CNL-17-144

December 20, 2017

Watts Bar Nuclear Plant, Units 1 and 2  
Facility Operating License Nos. NPF-90 and NPF-96  
NRC Docket Nos. 50-390 and 50-391

Subject: **Application to Revise Watts Bar Unit 2 Technical Specification 4.2.1, "Fuel Assemblies," and Watts Bar Units 1 and 2 Technical Specifications Related to Fuel Storage (WBN-TS-17-028)**

**FIGURE 4.3-3  
MINIMUM REQUIRED BURNUP FOR UNRESTRICTED STORAGE  
OF FUEL OF VARIOUS INITIAL ENRICHMENTS**

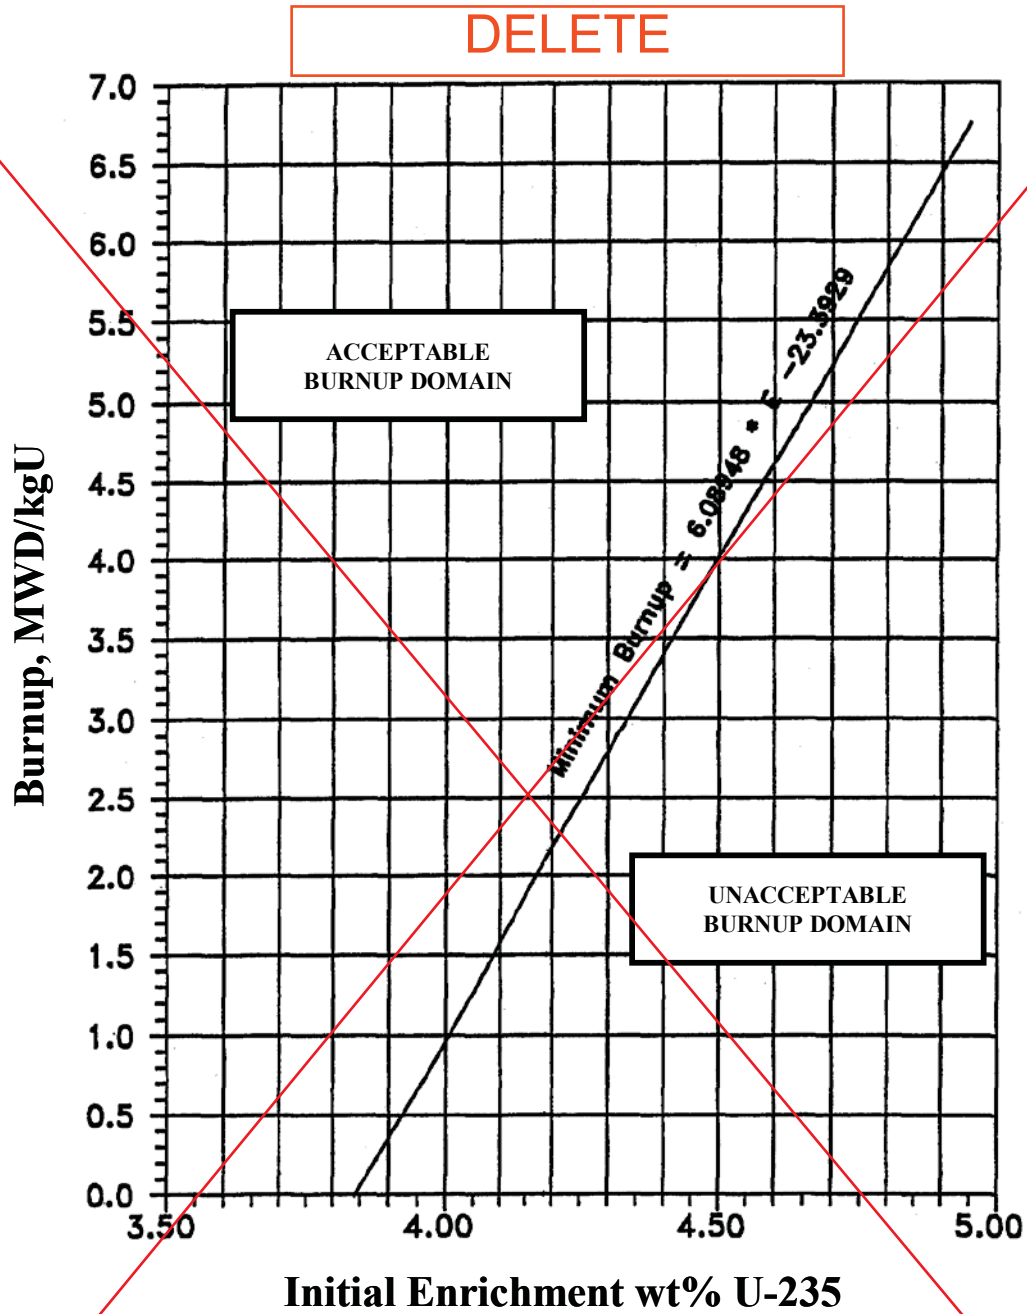
- ~~1. Fuel assemblies may be stored in the racks in an all cell arrangement provided the burnup of each assembly is in the acceptable domain identified in Figure 4.3-3, depending upon the specified initial enrichment.~~

**FIGURE 4.3-4**  
**MINIMUM REQUIRED BURNUP FOR A CHECKERBOARD ARRANGEMENT OF 2 SPENT AND 2**  
**NEW FUEL ASSEMBLIES OF 5wt% U-235 ENRICHMENT (MAXIMUM)**

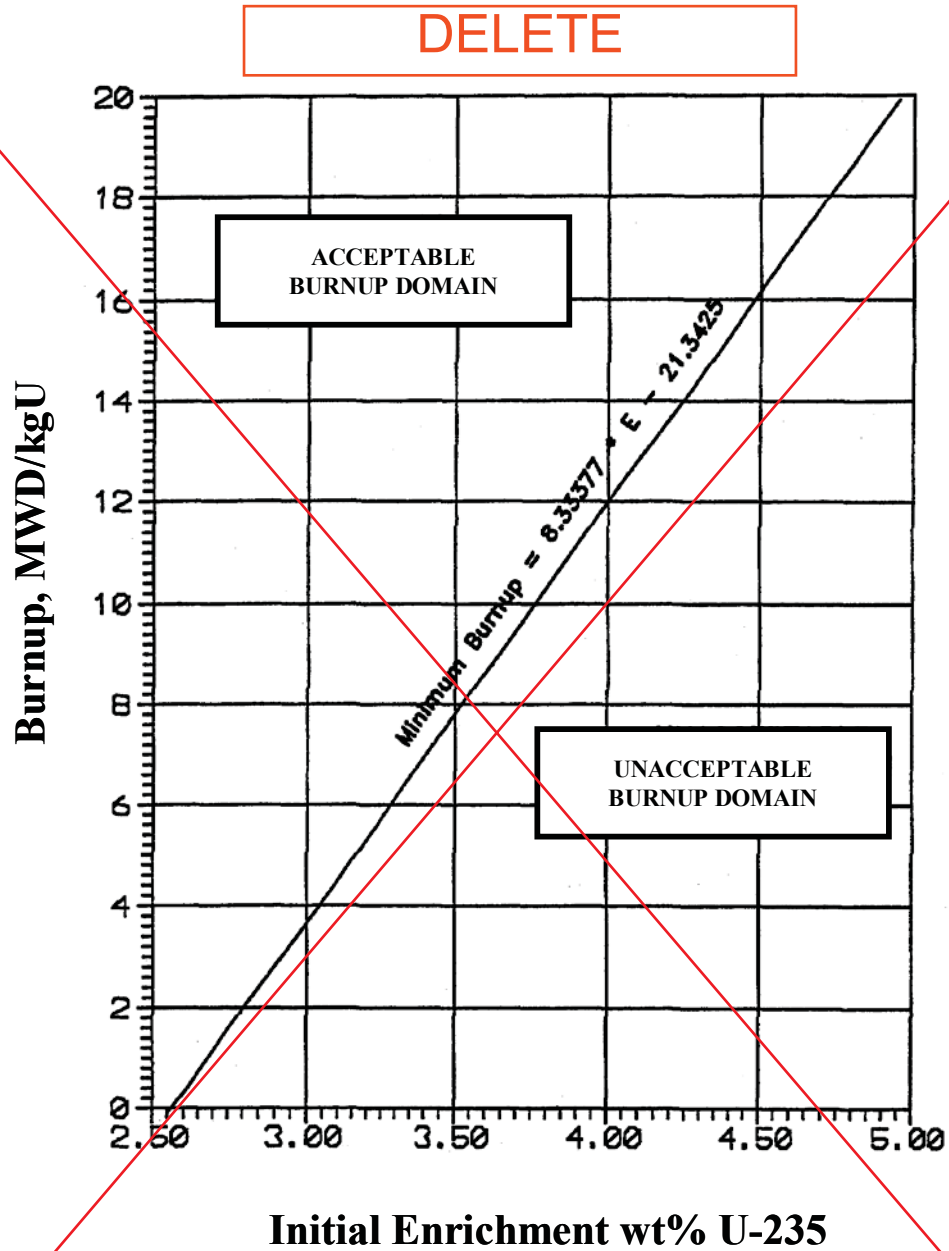
- ~~2. New and spent fuel assemblies may be stored in a checkerboard arrangement of 2 new and 2 spent assemblies, provided that each spent fuel assembly has accumulated a minimum burnup in the acceptable domain identified in Figure 4.3-4.~~

FIGURE 4.3-3  
MINIMUM REQUIRED BURNUP FOR UNRESTRICTED STORAGE  
OF FUEL OF VARIOUS INITIAL ENRICHMENTS

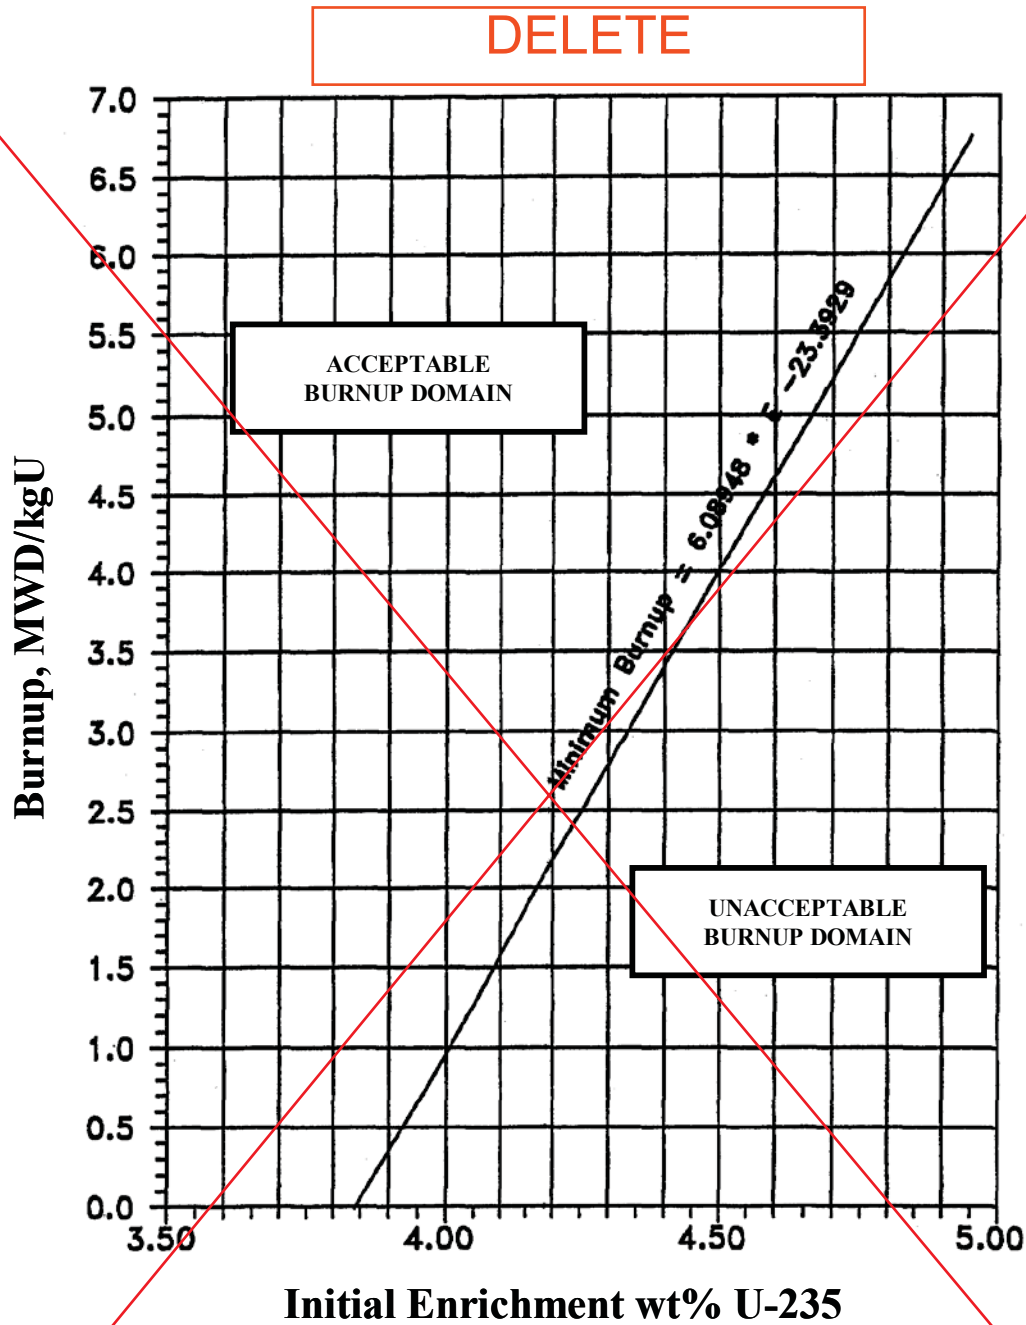
1. ~~Fuel assemblies may be stored in the racks in an all cell arrangement provided the burnup of each assembly is in the acceptable domain identified in Figure 4.3-3, depending upon the specified initial enrichment.~~

FIGURE 4.3-4  
MINIMUM REQUIRED BURNUP FOR A CHECKERBOARD ARRANGEMENT OF 2 SPENT  
AND 2 NEW FUEL ASSEMBLIES OF 5 wt% U-235 ENRICHMENT (MAXIMUM)

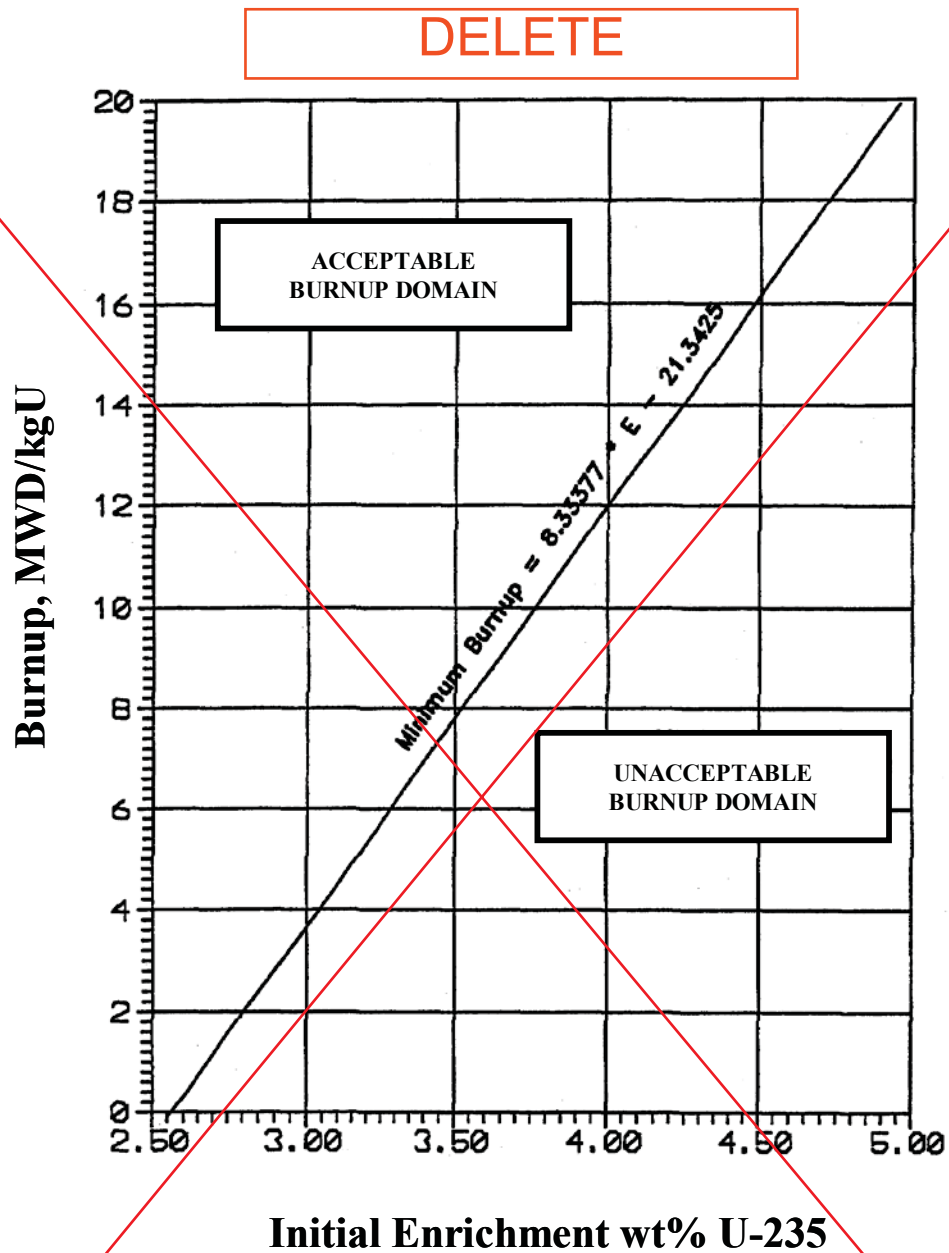
2. ~~New and spent fuel assemblies may be stored in a checkerboard arrangement of 2 new and 2 spent assemblies, provided that each spent fuel assembly has accumulated a minimum burnup in the acceptable domain identified in Figure 4.3-4.~~
